**Development Application and Planning Proposal Review
NSW Planning Portal Concurrence and Referral**

Authority	Authority's Reference	Agency Concurrence and Referral	Authority Contact	Authority Notification	Submission Due	Submission Made
NSW Dept. of Planning & Environment	SSD-41306367		Teresa Gizzi	8/11/2022	7/12/2022	10/11/2022

Address	Land Title
Gregory Hills Drive, Gregory Hills	Lot 3257 DP 1243285

Environmental Impact Statement (EIS) for the New Primary School at Gregory Hills. Construction of a new primary school comprising one and three storey buildings, outdoor play spaces, parking and associated works.

Figure E1: Electrical Infrastructure Site Plan

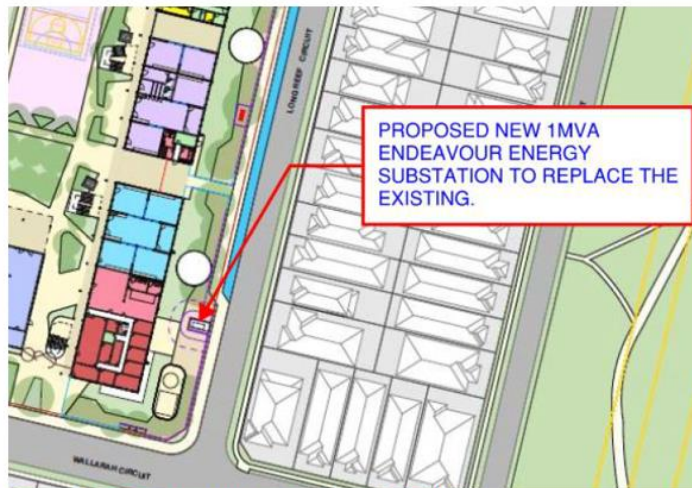
The site has existing utility substations located in both the south-eastern and north-western corners which are connected to the existing underground Endeavour Energy HV network.

Consultation with Endeavour Energy has advised that neither substation has sufficient capacity to provide the school with the required electrical power and hence an upgrade is required. It is proposed that the existing 315kVA substation located at the south-eastern property boundary is to be upgraded to a 1000kVA substation.

SITE PLAN - GF

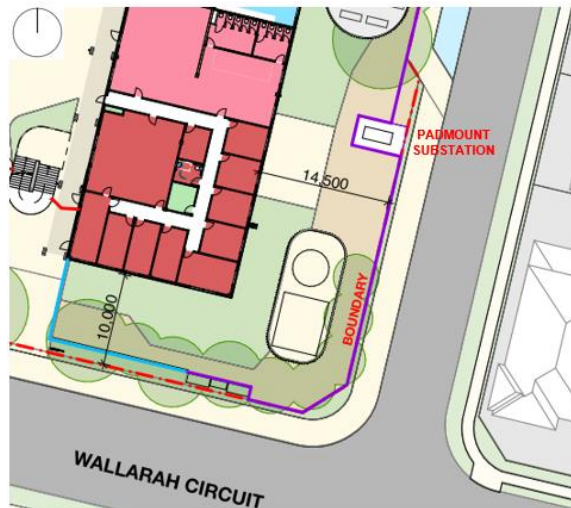
The Site Plan shows the padmount substation cubicle / plinth and possibly the easement but it does not show the restrictions. These are however shown in the above Figure E1 Electrical Infrastructure Site Plan but should be included in all the plans. There are no buildings or structures encroaching the easement or the restriction for fire rating and there is no swimming pool or spa proposed.

Site Plan from Endeavour Energy's G/Net Master Facility Model

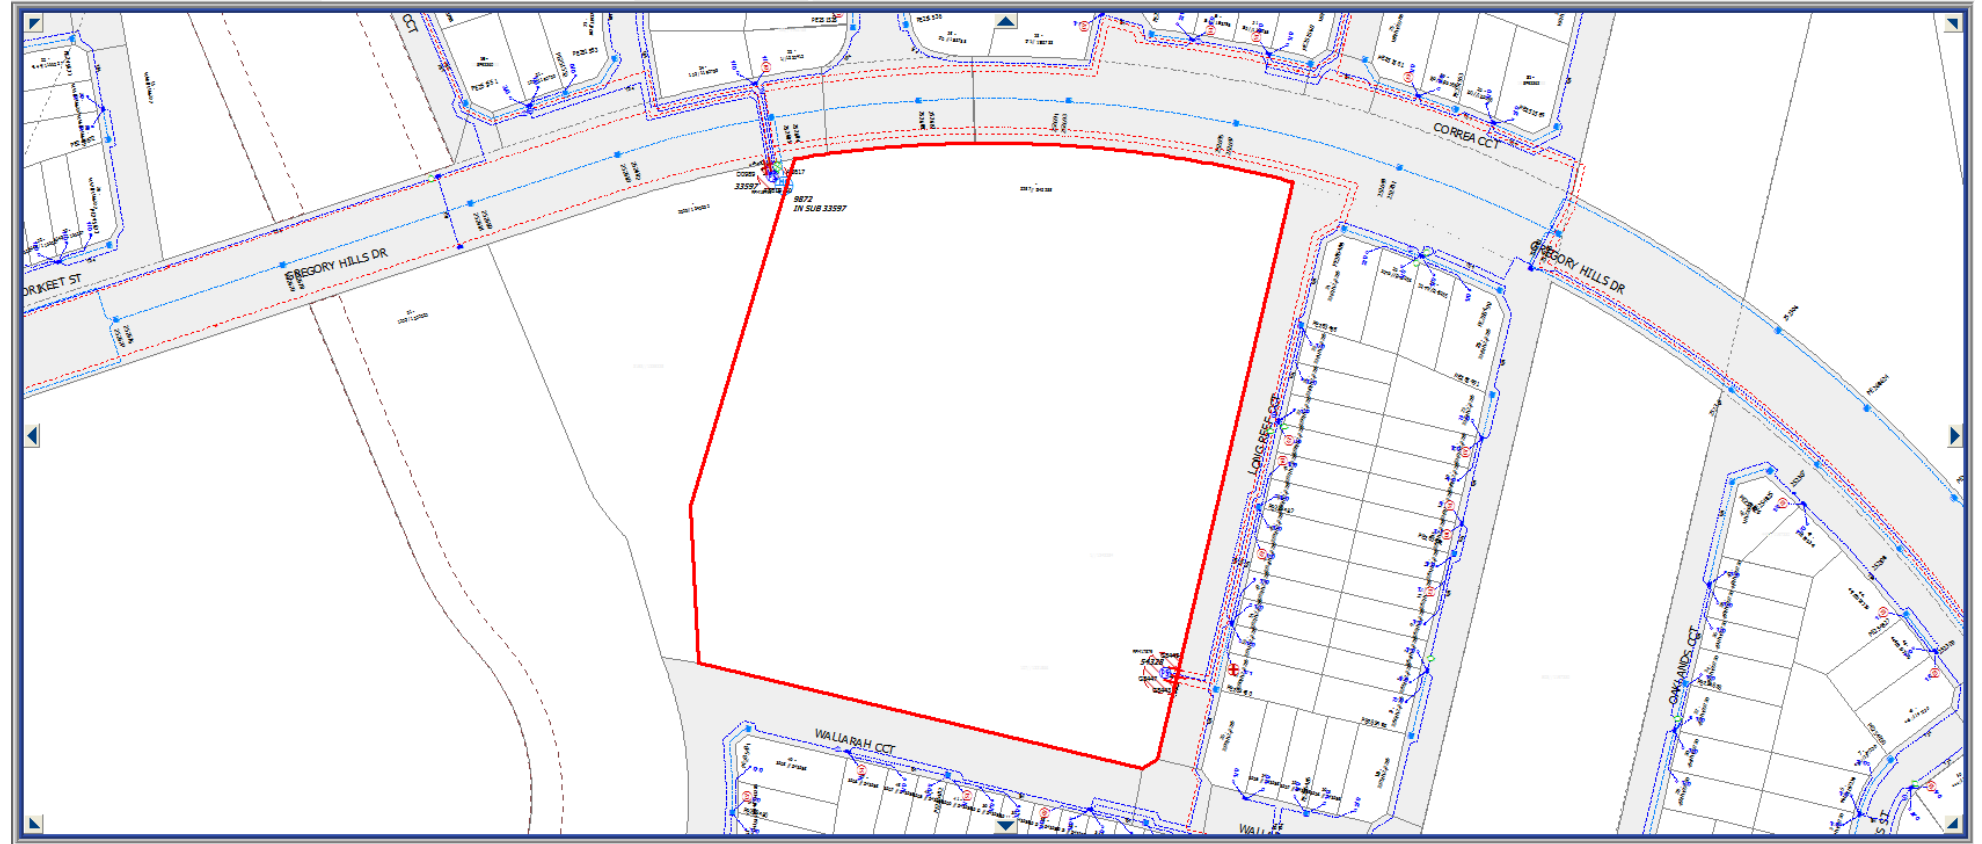
As shown in the below site plan from Endeavour Energy's G/Net master facility model:

- An easement and restrictions for fire rating and swimming pool or spa benefitting Endeavour Energy (indicated by red hatching) for padmount substation no. 54328.
- Low voltage and 11,000 volt / 11 kilovolt (kV) high voltage underground cables and underground earth cables to the Long Reef Circuit road verge / roadway.
- 11 kV high voltage underground cables to the Gregory Hills Drive road verge / roadway.
- Restriction for fire rating for padmount substation no. 33597 near the north western corner of the site to the Gregory Hills Drive road frontage in Howard Park.
